S E R V I C E N O T E

**Agilent E5100A/B Network Analyzer**

**A broken AC inlet may potentially result in a electric shock hazard.**

**ADMINISTRATIVE INFORMATION**

**Figure 1. AC Inlet Connector**

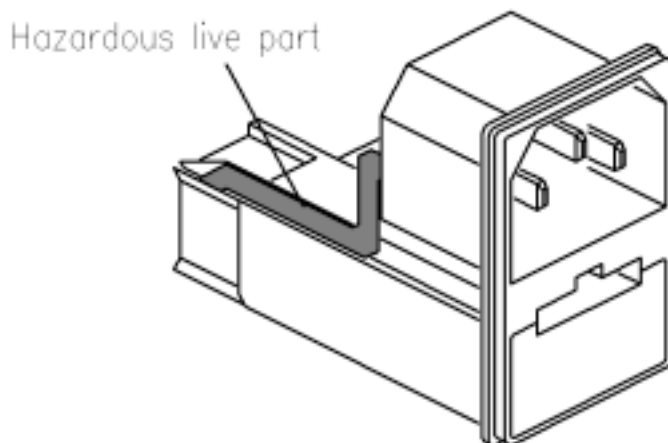
The AC inlet (P/N 1252-6951) has the potential to slip out of the instrument's rear panel slot if the AC power cord is forcefully pulled in a diagonal direction. When this happens, an exposed connection on the AC inlet module may touch the rear panel of the instrument and cause an electrical short if the AC power cord is still connected to the AC power outlet. See Figure 1.

In the worst case, there is also a possibility of an electric shock hazard to the user if the user completes a circuit between the instrument panel and another grounded connection while the AC power cord is still connected to the AC power outlet.

**Solution 1. AC Inlet Still Intact.**

- Remove the AC power cable from the AC power outlet and the product.
- Remove the top, bottom, and side covers.
- Seal the hot line terminal on the AC inlet with silicon paste (P/N 5183-4112).
- Reinforce the connection between the AC inlet and the rear panel with silicon paste.
- Perform Self Test to verify instrument operation.

**Figure 2. Repair Completed Label**

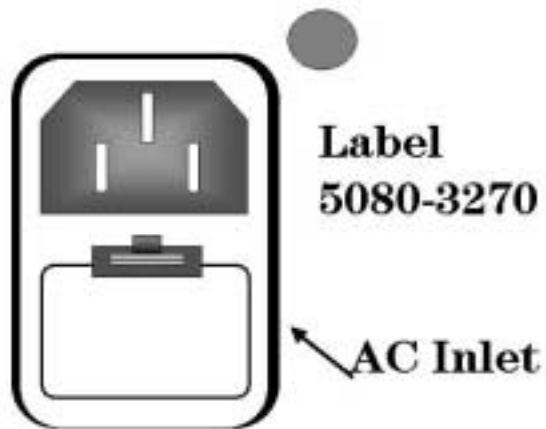
After completing the above instructions, stick the label (P/N 5080-3270) next to the AC Inlet on the rear panel as a mark that this repair has been completed. See Figure 2.
